STAFF REPORT

DATE: JUNE 19, 2018 AGENDA ITEM: 15

FROM: Emily Becker, Planning Director

ITEM: Boulder Ponds 3rd Addition – Final Plat, Final PUD Plan

3rd Addition Final Plat

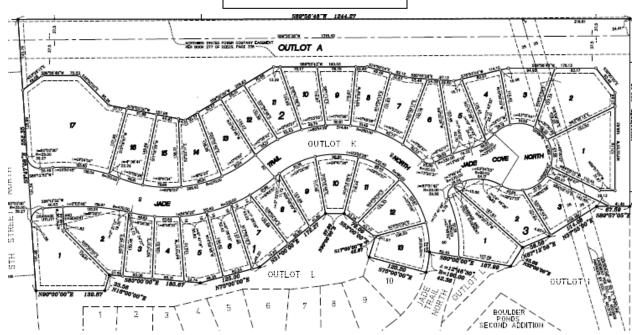
Changes to Final Plat from Preliminary Plat. Lot 17, Block 2 is much larger than originally approved with Preliminary Plat, and most of the remaining lots are smaller, as shown below. The applicant has indicated that future plans would be to submit for a PUD amendment in the future to increase the number of lots within the development by three or four. An analysis regarding these changes has been provided below.

• *Trails.* The northern trail has changed very slightly since preliminary plat as outlined below.

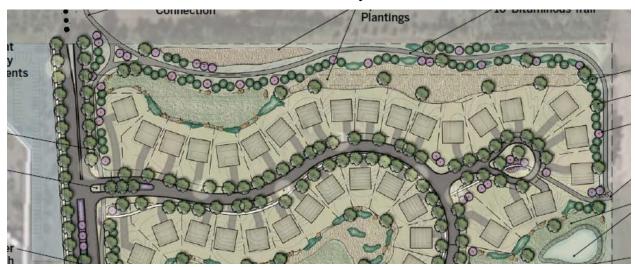
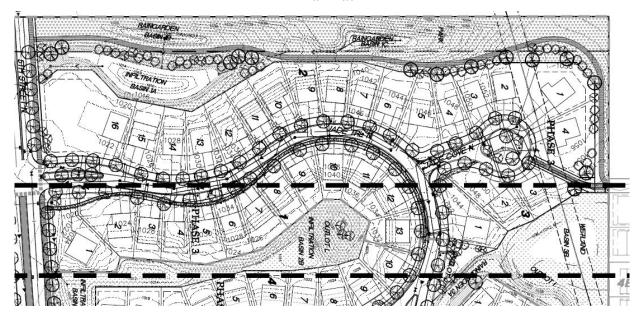
- 10) The eastern segment of the northern buffer trail shall be moved to the south to the greatest extent possible with plantings to screen the trail on the north side. Comments: It appears that the trail has been moved to the south to the greatest extent possible. However, no screening has been provided on the north side. It has been added as a condition of approval.

- 7) Plantings to sufficiently screen the northern portion of the northern buffer trail shall be provided on the Final Landscape Plan to be approved by the City's Landscape Architect.
